Product Change Notice (PCN)

Subject: Package assembly site addition for RZ/A1L (208pinLQFP)

PCN#:[EPPO-EX-25-0019-1]

Outline Drawing for current product:

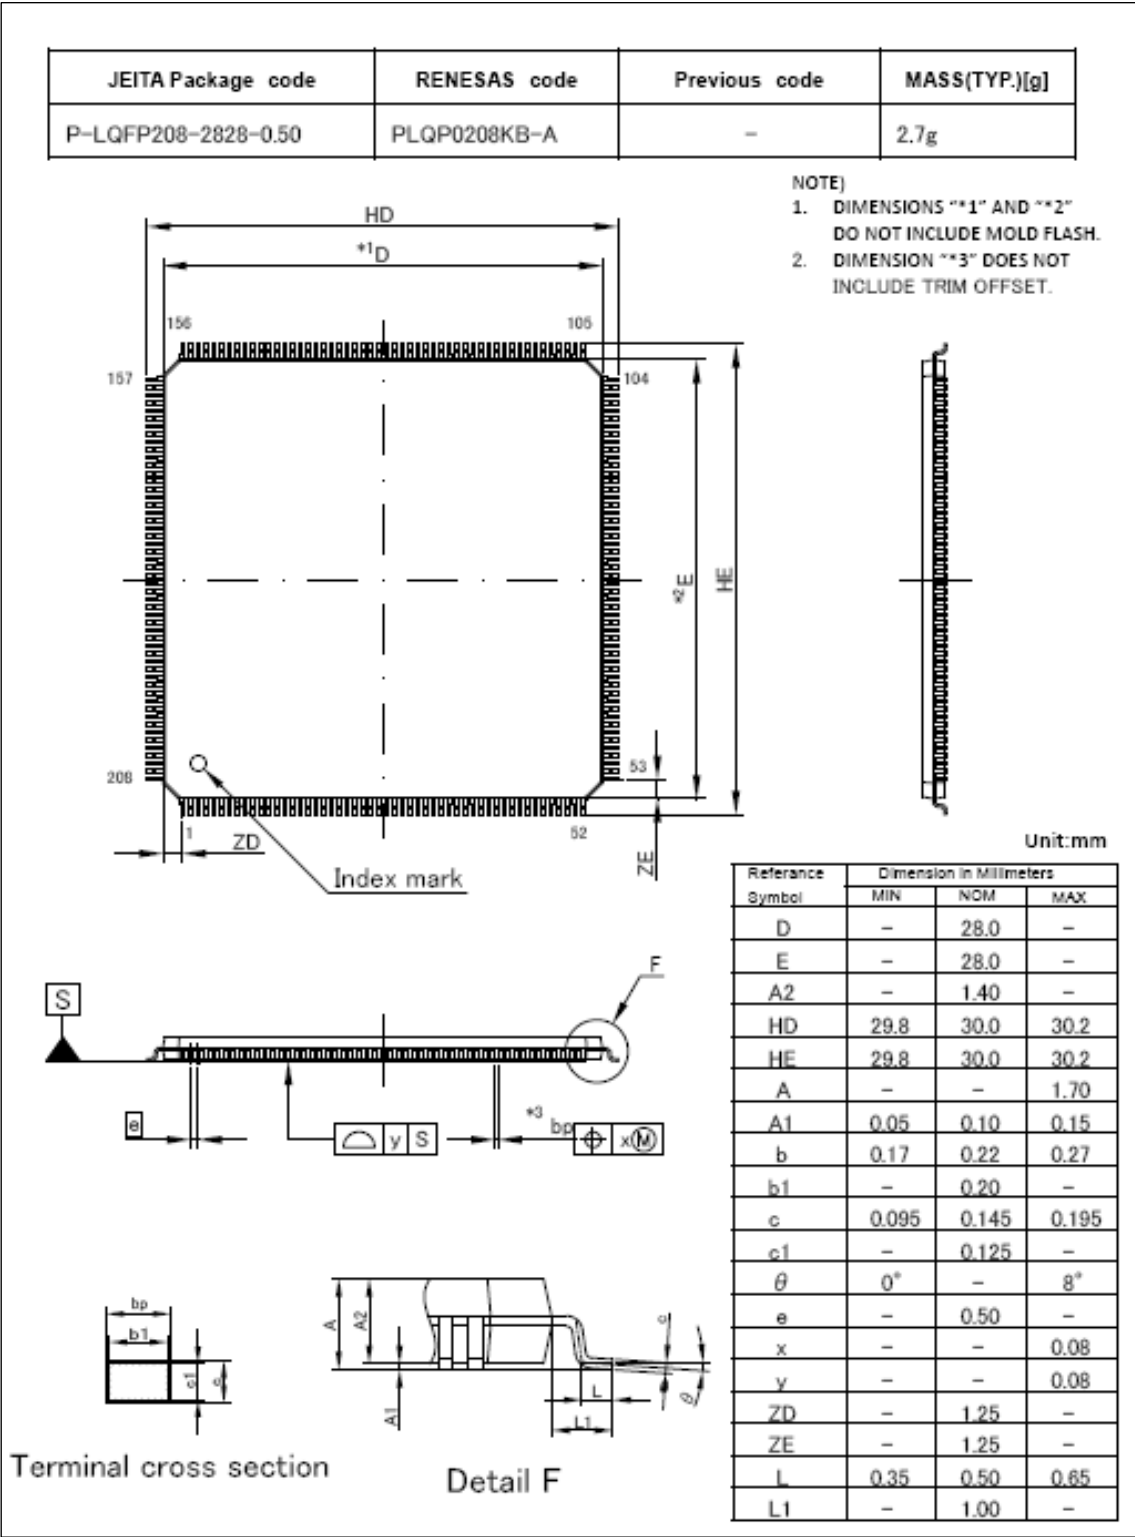
Form : Drawings of the current product and additional product are shown in the appendix.
Package outline is considered equivalent.

Current product	Additional product																																																																																																																																																																		
<table><tr><th rowspan="2">Reference Symbol</th><th colspan="3">Dimension in Millimeters</th></tr><tr><th>Min.</th><th>Nom.</th><th>Max.</th></tr><tr><td>A</td><td>—</td><td>—</td><td>1.7</td></tr><tr><td>A1</td><td>0.05</td><td>0.1</td><td>0.15</td></tr><tr><td>A2</td><td>—</td><td>1.4</td><td>—</td></tr><tr><td>HD</td><td>29.8</td><td>30</td><td>30.2</td></tr><tr><td>D</td><td>—</td><td>28</td><td>—</td></tr><tr><td>HE</td><td>29.8</td><td>30</td><td>30.2</td></tr><tr><td>E</td><td>—</td><td>28</td><td>—</td></tr><tr><td>e</td><td>—</td><td>0.5</td><td>—</td></tr><tr><td>b</td><td>0.17</td><td>0.22</td><td>0.27</td></tr><tr><td>c</td><td>0.095</td><td>0.145</td><td>0.195</td></tr><tr><td>θ</td><td>0°</td><td>—</td><td>8°</td></tr><tr><td>L</td><td>0.35</td><td>0.5</td><td>0.65</td></tr><tr><td>L1</td><td>—</td><td>1.00</td><td>—</td></tr><tr><td>b1</td><td>—</td><td>0.2</td><td>—</td></tr><tr><td>c1</td><td>—</td><td>0.125</td><td>—</td></tr><tr><td>x</td><td>—</td><td>—</td><td>0.08</td></tr><tr><td>y</td><td>—</td><td>—</td><td>0.08</td></tr><tr><td>ZD</td><td>—</td><td>1.25</td><td>—</td></tr><tr><td>ZE</td><td>—</td><td>1.25</td><td>—</td></tr></table>	Reference Symbol	Dimension in Millimeters			Min.	Nom.	Max.	A	—	—	1.7	A1	0.05	0.1	0.15	A2	—	1.4	—	HD	29.8	30	30.2	D	—	28	—	HE	29.8	30	30.2	E	—	28	—	e	—	0.5	—	b	0.17	0.22	0.27	c	0.095	0.145	0.195	θ	0°	—	8°	L	0.35	0.5	0.65	L1	—	1.00	—	b1	—	0.2	—	c1	—	0.125	—	x	—	—	0.08	y	—	—	0.08	ZD	—	1.25	—	ZE	—	1.25	—	<table><tr><th rowspan="2">Reference Symbol</th><th colspan="3">Dimension in Millimeters</th></tr><tr><th>Min.</th><th>Nom.</th><th>Max.</th></tr><tr><td>A</td><td>—</td><td>—</td><td>1.7</td></tr><tr><td>A1</td><td>0.05</td><td>—</td><td>0.15</td></tr><tr><td>A2</td><td>1.35</td><td>1.4</td><td>1.45</td></tr><tr><td>D</td><td></td><td>30 BSC.</td><td></td></tr><tr><td>D1</td><td></td><td>28 BSC.</td><td></td></tr><tr><td>E</td><td></td><td>30 BSC.</td><td></td></tr><tr><td>E1</td><td></td><td>28 BSC.</td><td></td></tr><tr><td>N</td><td>—</td><td>208</td><td>—</td></tr><tr><td>e</td><td></td><td>0.5 BSC.</td><td></td></tr><tr><td>b</td><td>0.17</td><td>0.22</td><td>0.27</td></tr><tr><td>c</td><td>0.095</td><td>—</td><td>0.195</td></tr><tr><td>q</td><td>0°</td><td>3.5°</td><td>8°</td></tr><tr><td>L</td><td>0.35</td><td>0.5</td><td>0.65</td></tr><tr><td>L1</td><td colspan="3">1.00 REF.</td></tr><tr><td>aaa</td><td>—</td><td>—</td><td>0.2</td></tr><tr><td>bbb</td><td>—</td><td>—</td><td>0.2</td></tr><tr><td>ccc</td><td>—</td><td>—</td><td>0.08</td></tr><tr><td>ddd</td><td>—</td><td>—</td><td>0.08</td></tr></table>	Reference Symbol	Dimension in Millimeters			Min.	Nom.	Max.	A	—	—	1.7	A1	0.05	—	0.15	A2	1.35	1.4	1.45	D		30 BSC.		D1		28 BSC.		E		30 BSC.		E1		28 BSC.		N	—	208	—	e		0.5 BSC.		b	0.17	0.22	0.27	c	0.095	—	0.195	q	0°	3.5°	8°	L	0.35	0.5	0.65	L1	1.00 REF.			aaa	—	—	0.2	bbb	—	—	0.2	ccc	—	—	0.08	ddd	—	—	0.08

Outline Drawing for additional product:

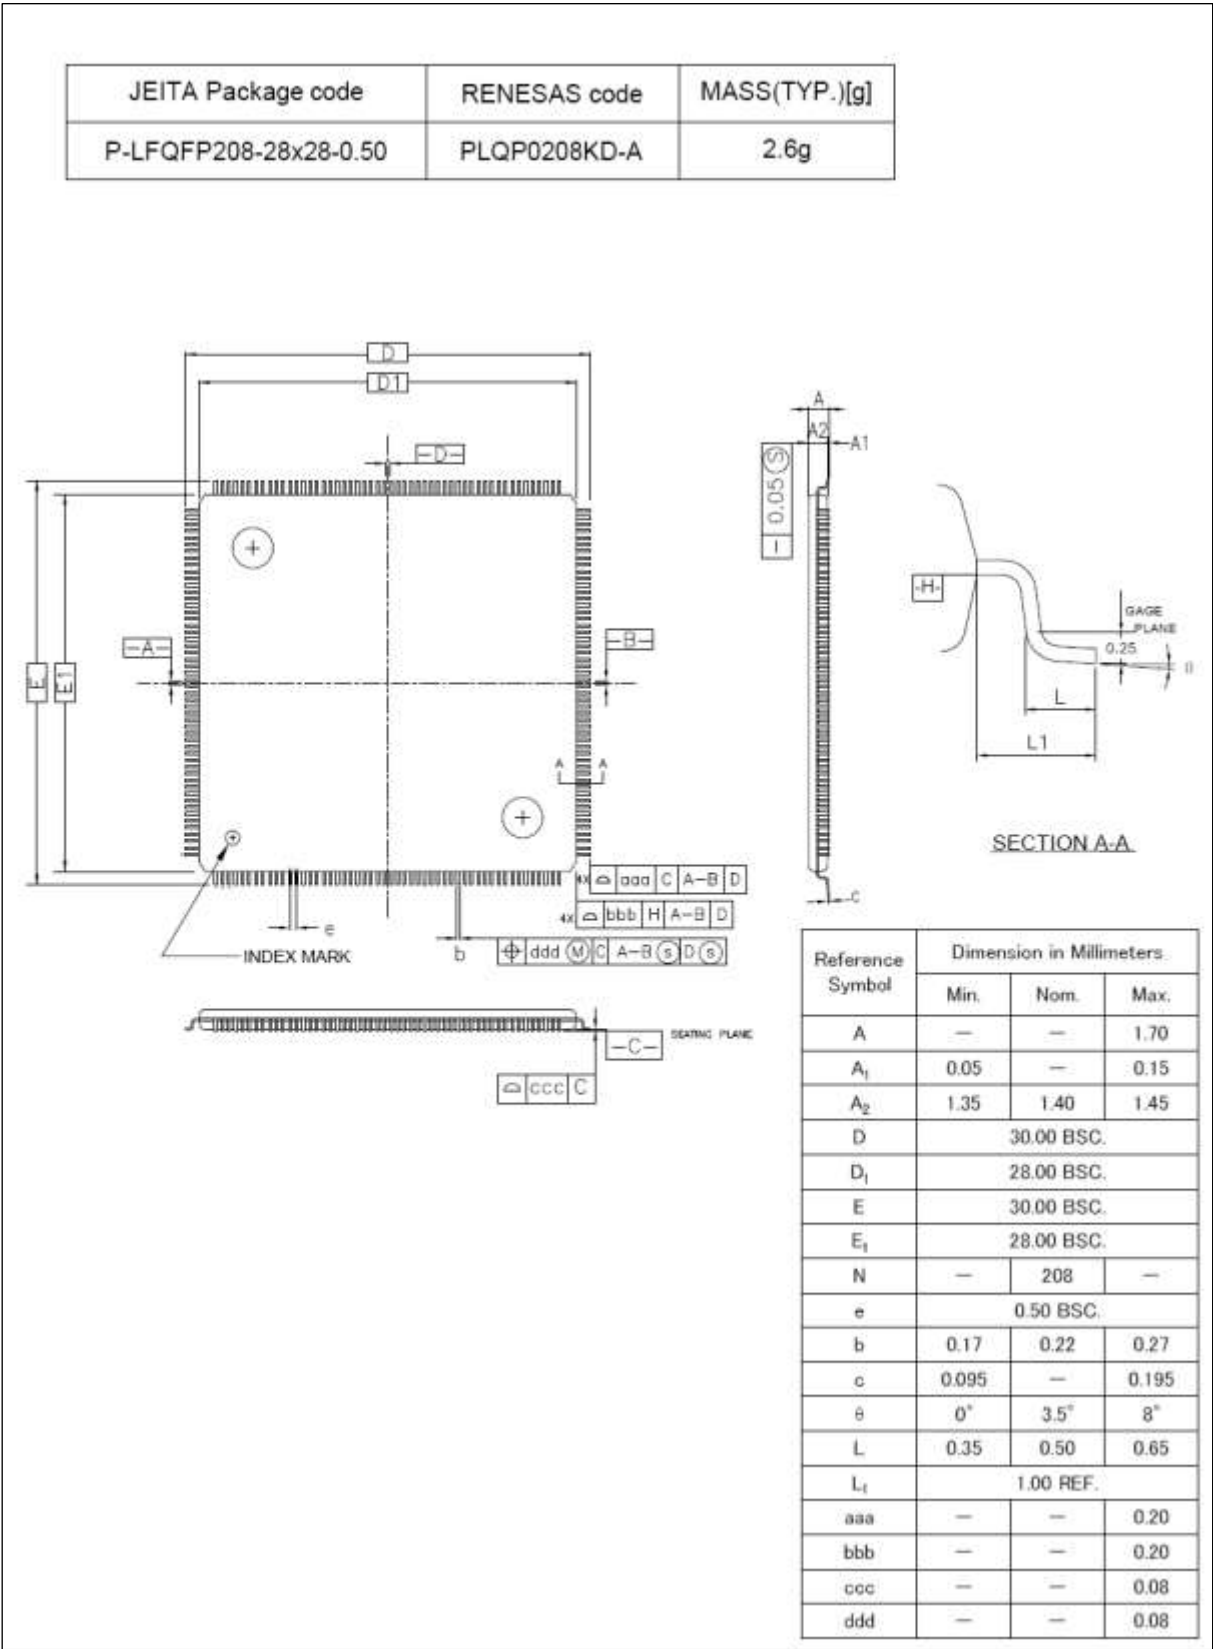
The Booking part numbers will be changed for identification because a part of package outline will also be changed from the current product.
